GEORGETOWN-SCOTT COUNTY PLANNING COMMISSION

**AGENDA
JUNE 9, 2022
6:00 p.m.**

**PARKVIEW MEDICAL PLAZA
PRELIMINARY DEVELOPMENT PLANS**

**Staff Report to the Georgetown-Scott County Planning Commission
JUNE 9, 2022**

PRELIMINARY SITE DEVELOPMENT PLAN
PARKVIEW MEDICAL PLAZA - PHASE 2
US2-62 PARTNERS, LLC.
1191 LEXINGTON ROAD
GEORGETOWN, SCOTT COUNTY, KENTUCKY

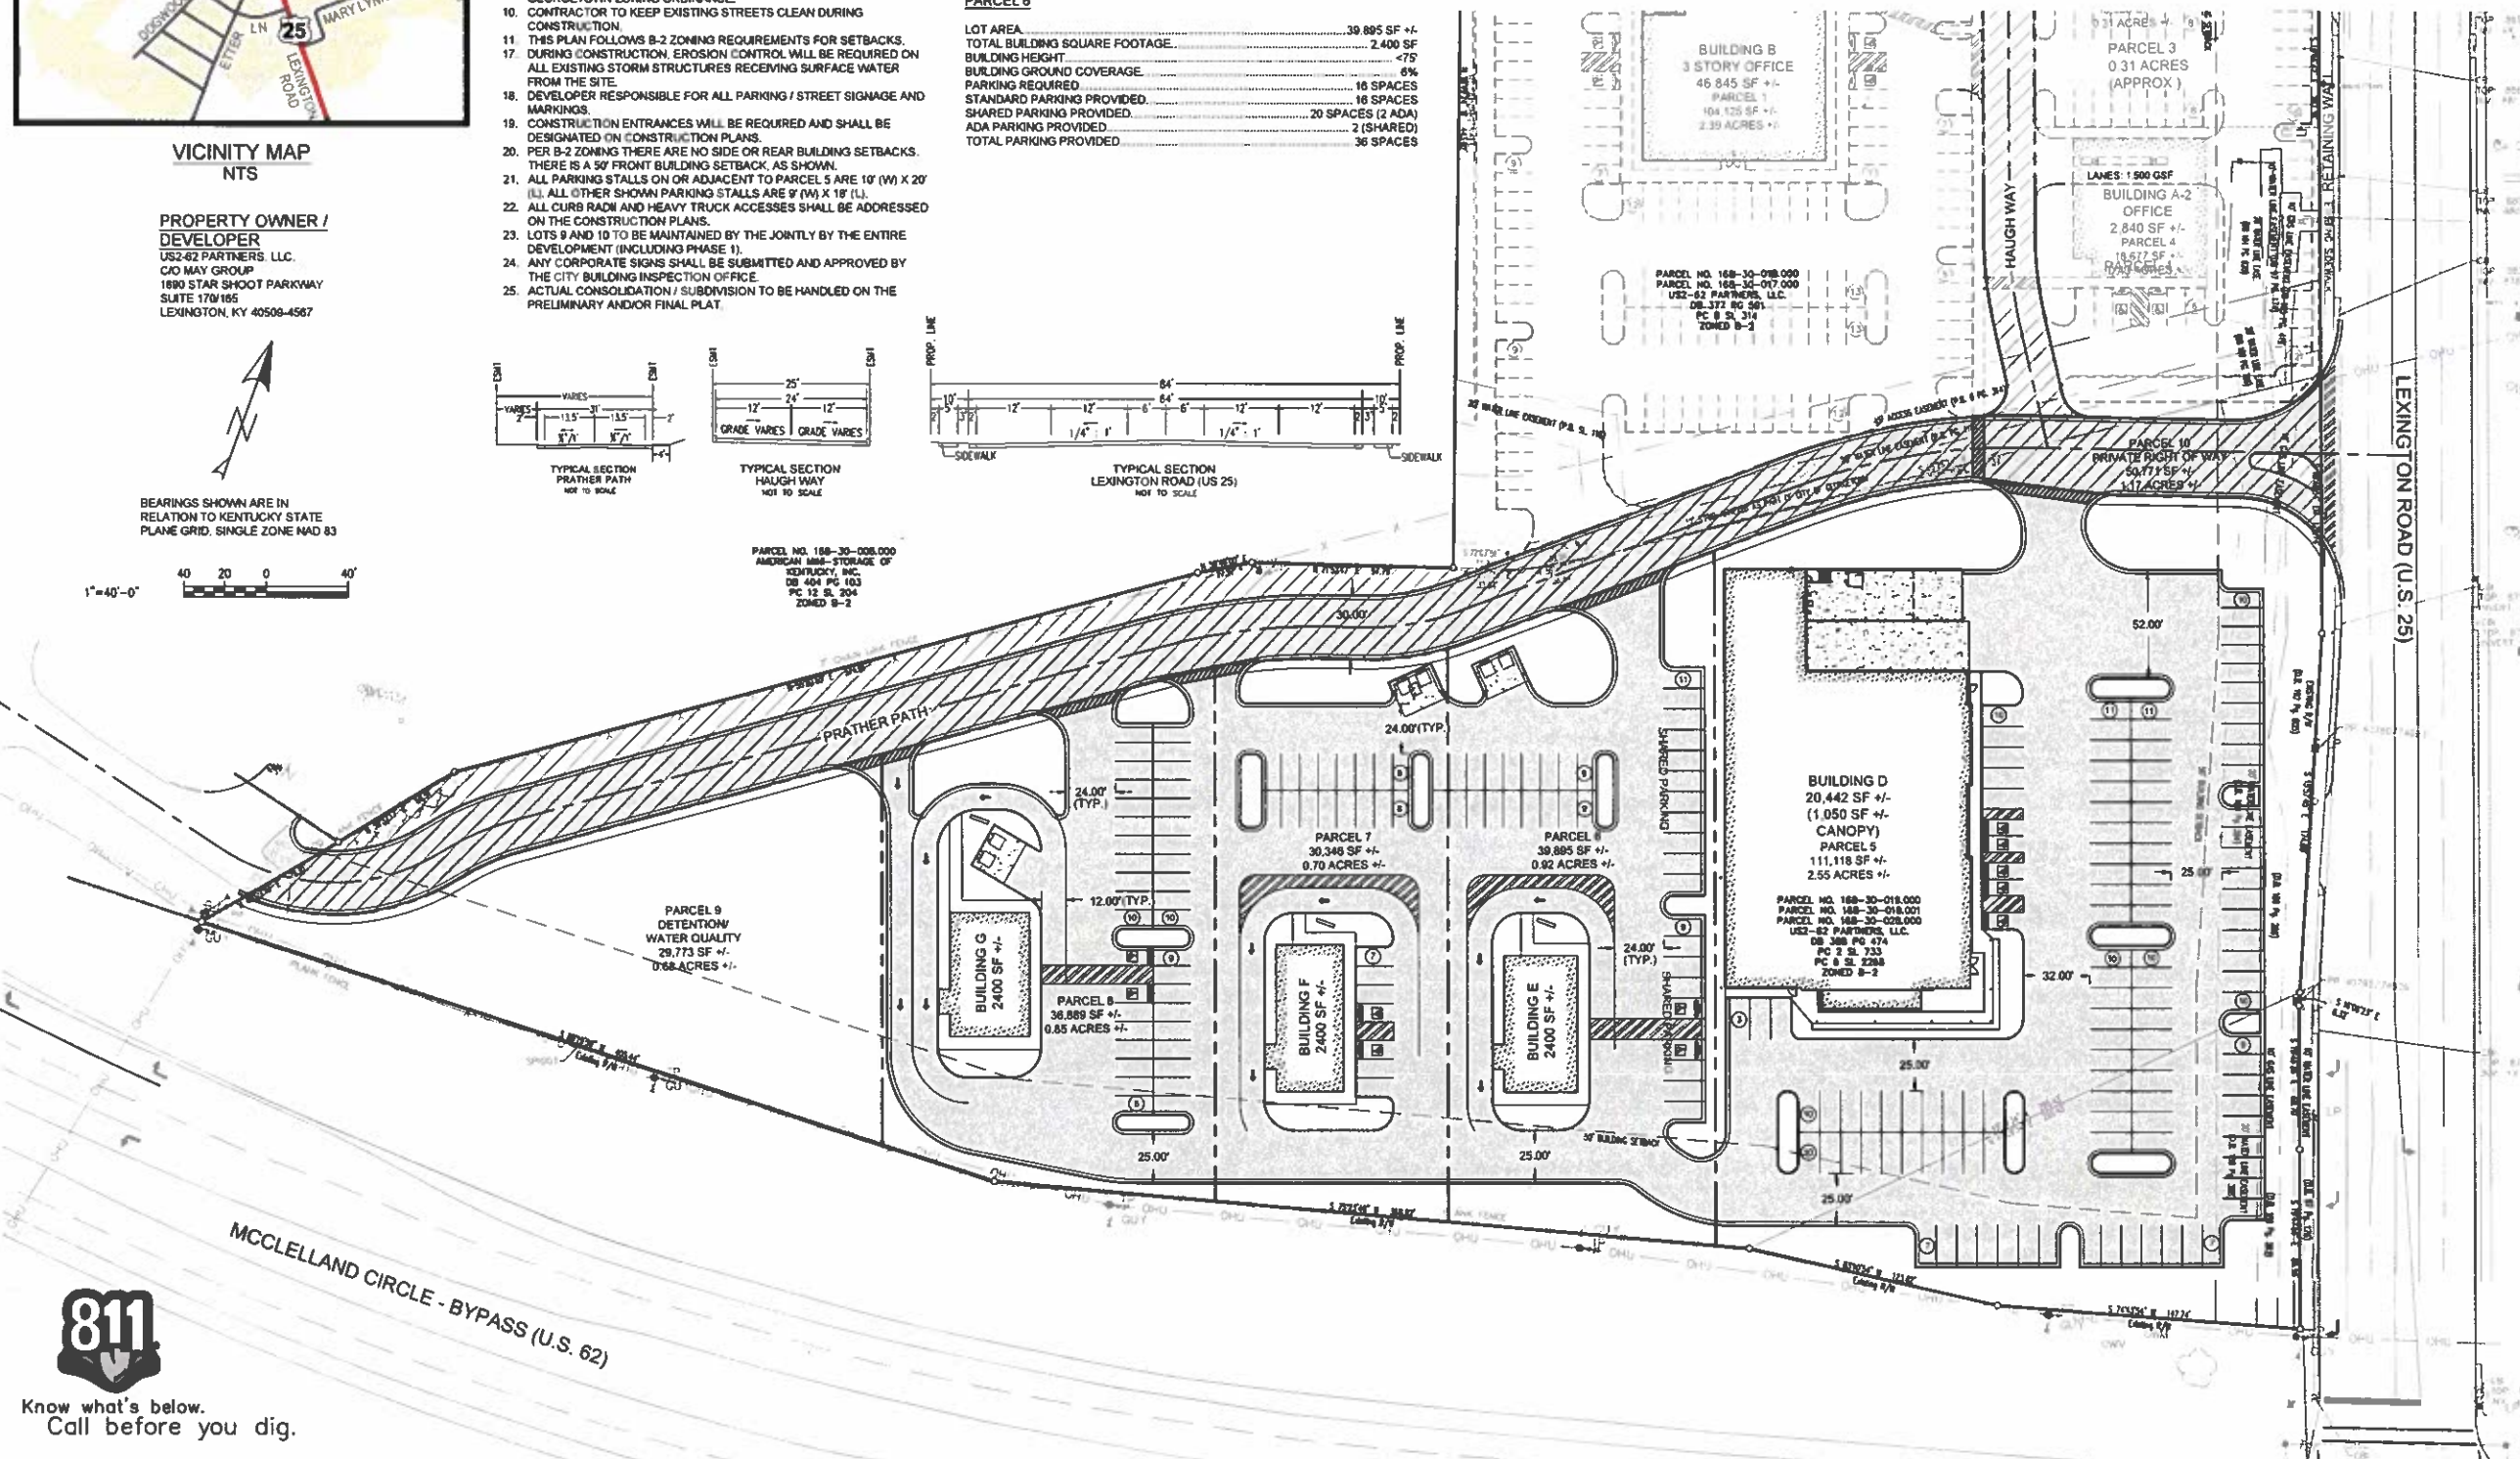
The overall site (Phases 1 & 2) proposes three main vehicular access points. There will be access to the site from Lusby Path, access from Lexington Road (US 25), and access from American Path. The Preliminary Development Plan shows pedestrian access will be provided along the internal private streets.

The plan proposes a direct access to the site from US 25 for a new shared private road (Prather Path). The private road would connect from US 25 through the site to American Path on the western side. The plan also proposes a new private road (Haugh Path) connecting the proposed Prather Path to Lusby Path.

The Preliminary Development Plan appears to meet this requirement except along Lexington Road (US 25) and no waivers/variances have been requested. There are several issues to navigate along the eastern boundary, so it may be necessary, on the Final Development Plan, to adjust the site layout to accommodate the required buffering.

1. All applicable requirements of the *Zoning Ordinance* and *Subdivision & Development Regulations*.
2. The Applicant shall construct turn lanes on Lusby Path and work with KYTC on installation of a traffic signal, as described in the Traffic Impact Study, as part of the Final Development Plan for the Project Site.

3. As part of the Final Development Plan, the Applicant shall realign American Path to intersect with Lusby Path at a safer location to accommodate the trips generated by the Project Site.
